From: Rajesh Kodali <rajeshkodali@gmail.com>
Sent: Monday, January 06, 2020 2:05 PM
To: Design Review Board; Tony Leavitt; Kurt Triplett
Subject: Public Comment on Continental Divide Project DRV18-00312

From: Diana Moore <Diana@TheBestAgent4U.com>
Sent: Saturday, November 16, 2019 12:43 PM
To: Design Review Board; Tony Leavitt; Adam Weinstein; Kurt Triplett
Subject: Public Comment on Continental Divide Project DRV18-00312
Attachments: Continental Divide_Design Review Report_Adams Architecture_20181129.pdf

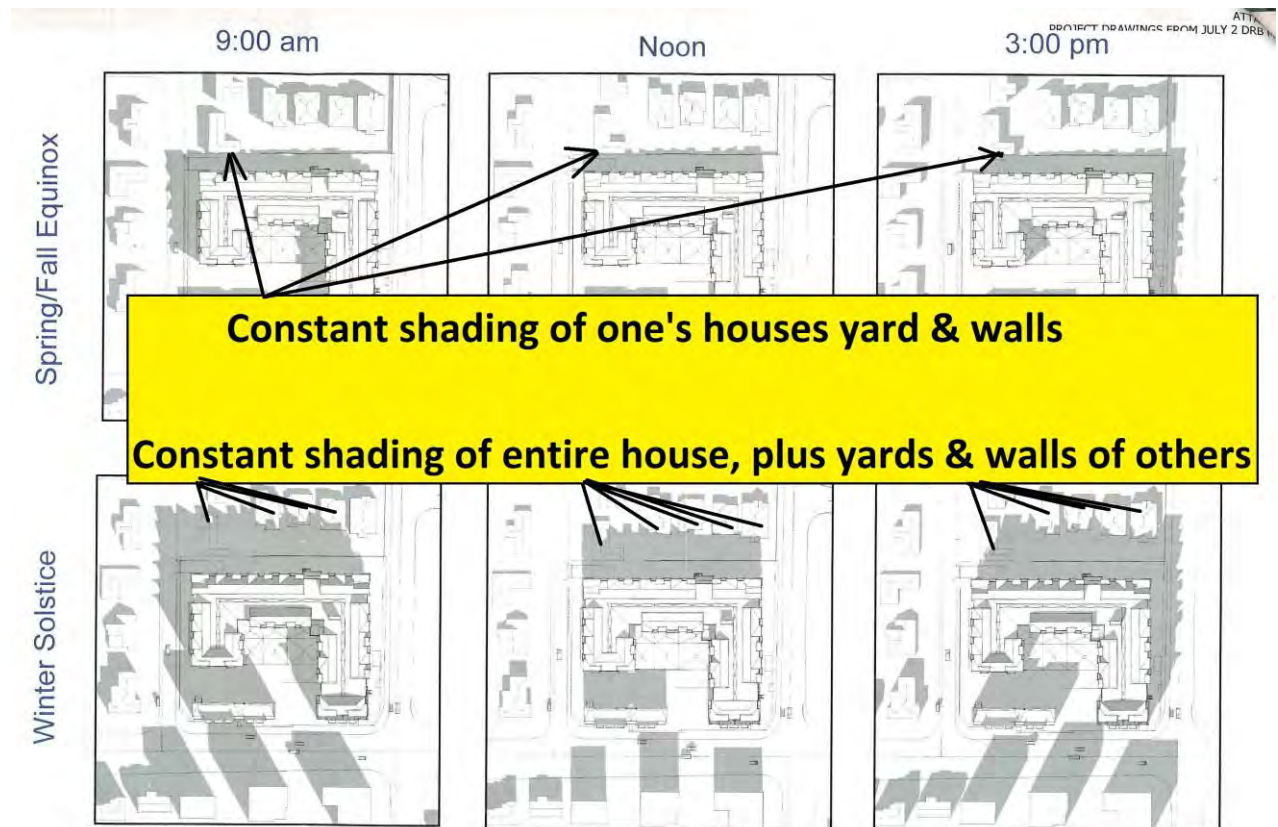
The developer must submit a tree retention plan. KZC 95.30.3. It does not appear a tree retention plan has been submitted.

If there are any high-value trees—meaning “specimen trees” (six-inch-dbh significant trees in excellent health) located within a required yard or planting buffer, or on a slope greater than 10%—these high-value trees must be preserved “to the maximum extent possible.” KZC 95.30.5 Chart. All other six-inch-dbh significant trees are to be retained if feasible, meaning they must be preserved if they do not interfere with the intended development. KZC 95.30.5 Chart. It is unknown what significant trees exist in the required yards or buffers, however, current plans do not appear to call for the retention of any existing significant trees, which could be a violation of this provision, depending on whether the existing significant trees (if any) are healthy and sit within the required yards or buffers.

In addition to the tree retention plan, the developer must also file a tree maintenance plan aimed at preserving all retained trees and all planted trees. KZC 95.51. The developer does not appear to have filed a tree maintenance plan. This is another violation.

The developer must provide an accurate inventory of trees and a plan for retaining them. Until that happens, this project cannot be fully evaluated.

[+CAM18-00363_Part3.pdf](#) p45

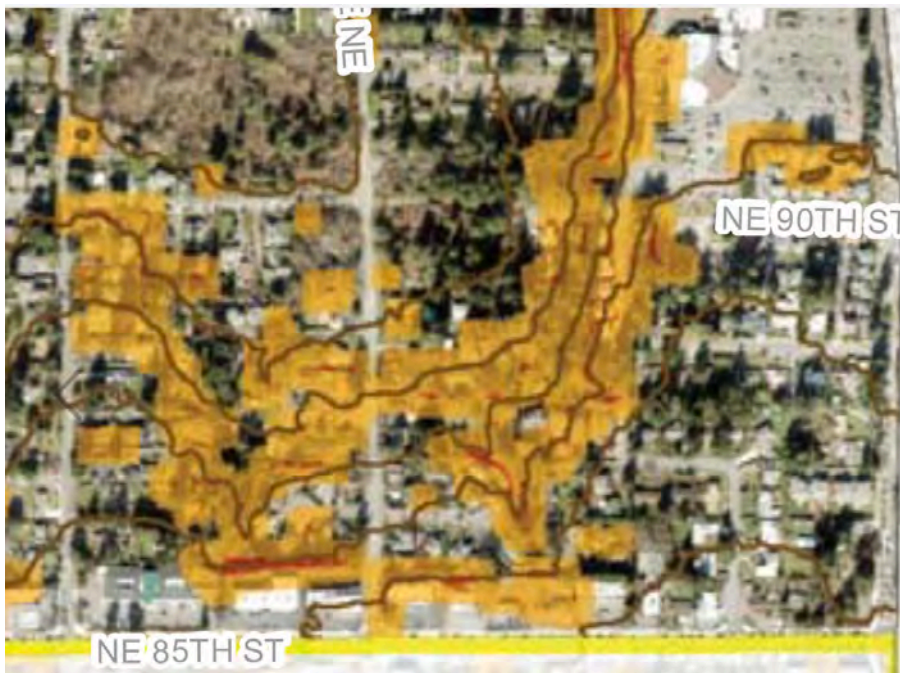
In the most recent Kirkland Liquefaction / Mudslide potential maps (2018 City Initiated Comprehensive Plan Amendments, File Number CAM18-00363) the development of creating a connecting roadway at 130TH Ave NE between NE 87th ST and NE 94th ST will increase require removal of all major trees and increase the 30 degree grade of our property. Increasing steepness in a wetland drainage area dramatically increase the risk of a slide on our property. This action would effectively change our property designation from “moderate” landslide risk to “high” landslide risk. This will also increase the danger of a slide and damage to the home of our closest downhill neighbor, located at 12923 NE 88th St, as well as the other homeowners further down the hill.

The street drains for 87th Street NE drain out onto our property, to the south of our home, and our property was recently designated a critical wetland drainage area. Building the 130th Av NE connector would increase the grade and water draining onto our property and onto the home downhill, 12923 NE 88th St, leading to additional flooding and mudslide potential. Building a road on a wetland is contrary to Resolution 2017-2: Chapter 90 KZC Amendments (Critical Area Ordinance/Wetlands, Streams, Fish and Wildlife Conservation Areas, Minor Lakes and Frequently Flooded Areas) and related minor code amendments (CAM15-01832) <https://www.kirklandwa.gov/Assets/Planning/Planning+PDFs/Houghton+Community+Council/Chapter+90+HCC+Meeting+Packet+01262017+-+CAM15-01832.pdf>

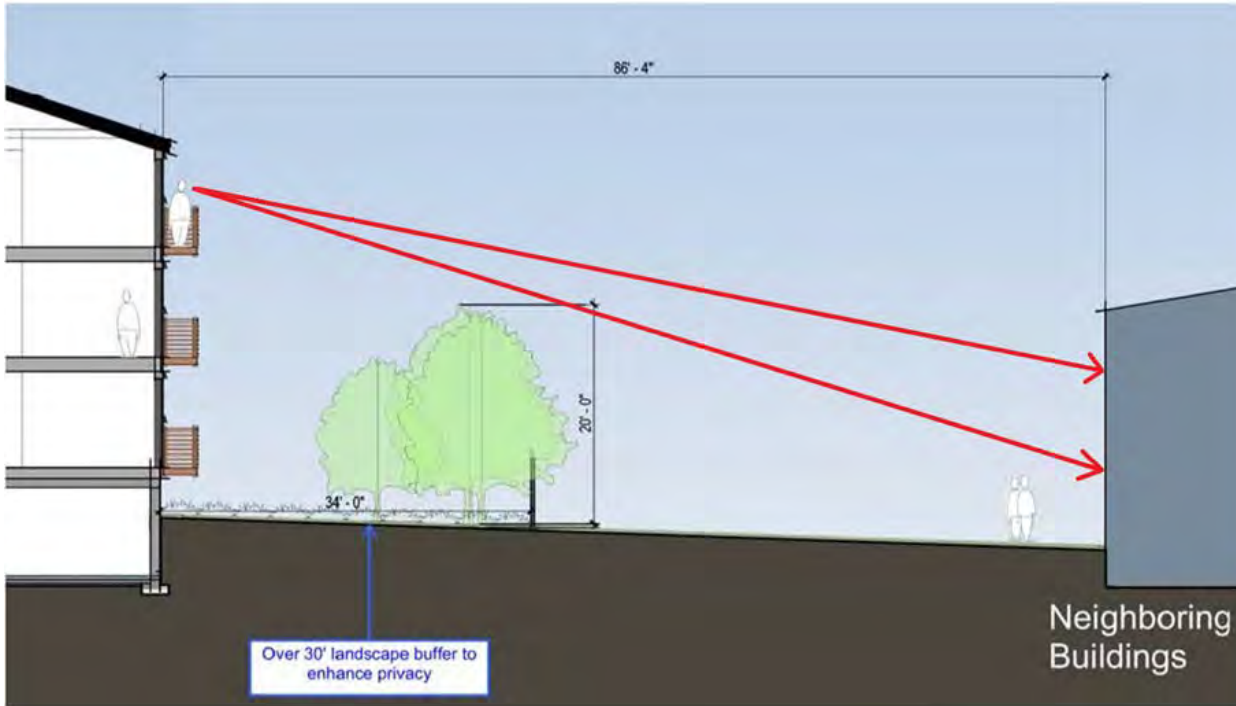
However, the current design of the continental divide project doesn't meet the requirements. While I appreciated builder's effort to put in a 30 ft landscape buffer and reduce number of balconies, I don't believe current design enough to protect the privacy. Below is the "North context elevation" picture provided by the builder (page 66 of

<https://www.kirklandwa.gov/Assets/Planning/Planning+PDFs/Design+Review+Board/Continental+Divide+DRB+Meeting+Packet+08062018+-+DRV18-00312.pdf>). There are still good amount of windows AND balconies directly facing adjacent homes.

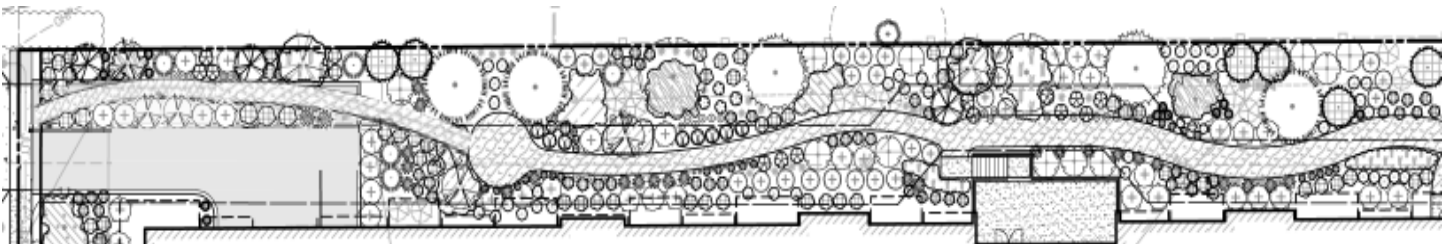
residences of the continental divide have unobscured views into both 1st and 2nd floor adjacent homes.

- Trees take time to grow to 20 ft tall. Let's say the initial height of the trees are 6 ft (normal height for newly planted trees) and every year they grow 3 ft (very fast growing trees). It will take about 5 years for the trees to grow to 20 ft height. So for the first 5 years or so, almost all residents in that building has clear views in to our house.
- Current landscape design doesn't seem to be able to provide privacy throughout the north side of the site. There are lots of gaps between big/tall trees.

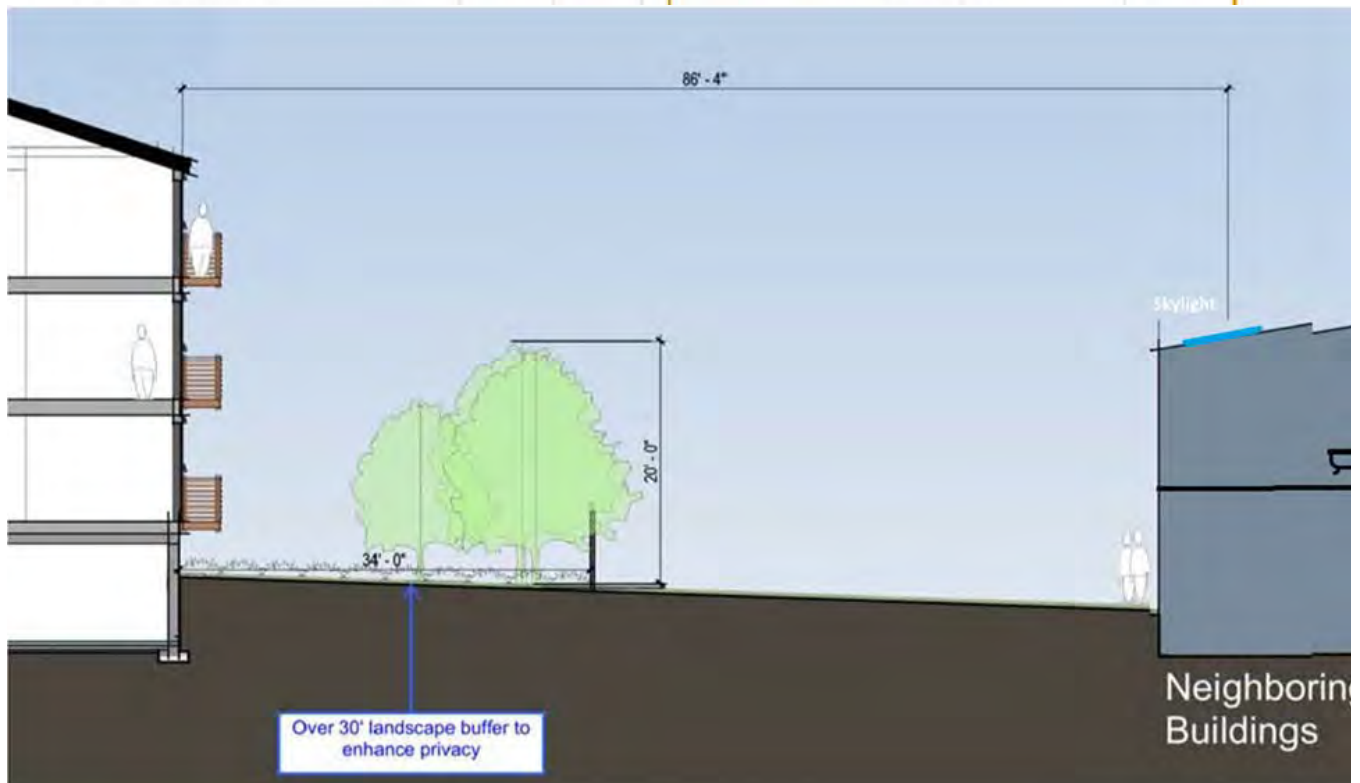
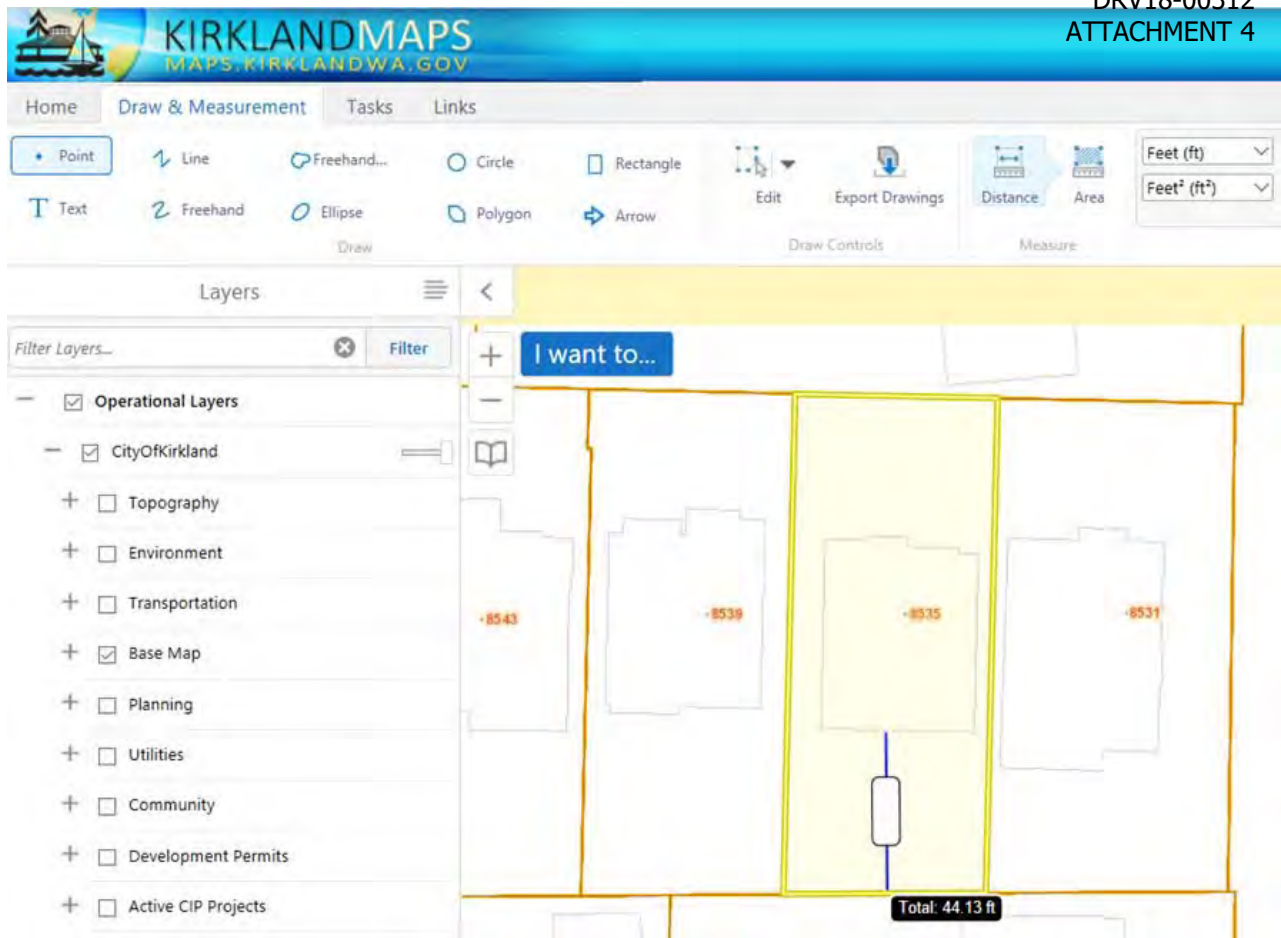
- Deciduous trees (e.g. maple) can provide no privacy in winter time. Therefore evergreen trees must be planted along the north side.
- According to Kirkland maps, my house (8535 132nd Ave NE) is actually about 44 ft away from the property line, which is 8 ft closer then what was showing in the picture above. I have skylight on the roof (in my bathroom!). The top floor residents of continent divide likely will have a nice view looking into my bath tub and shower!

Therefore, the current design is not compliant with design guideline 5.d that DRB should not approve it.
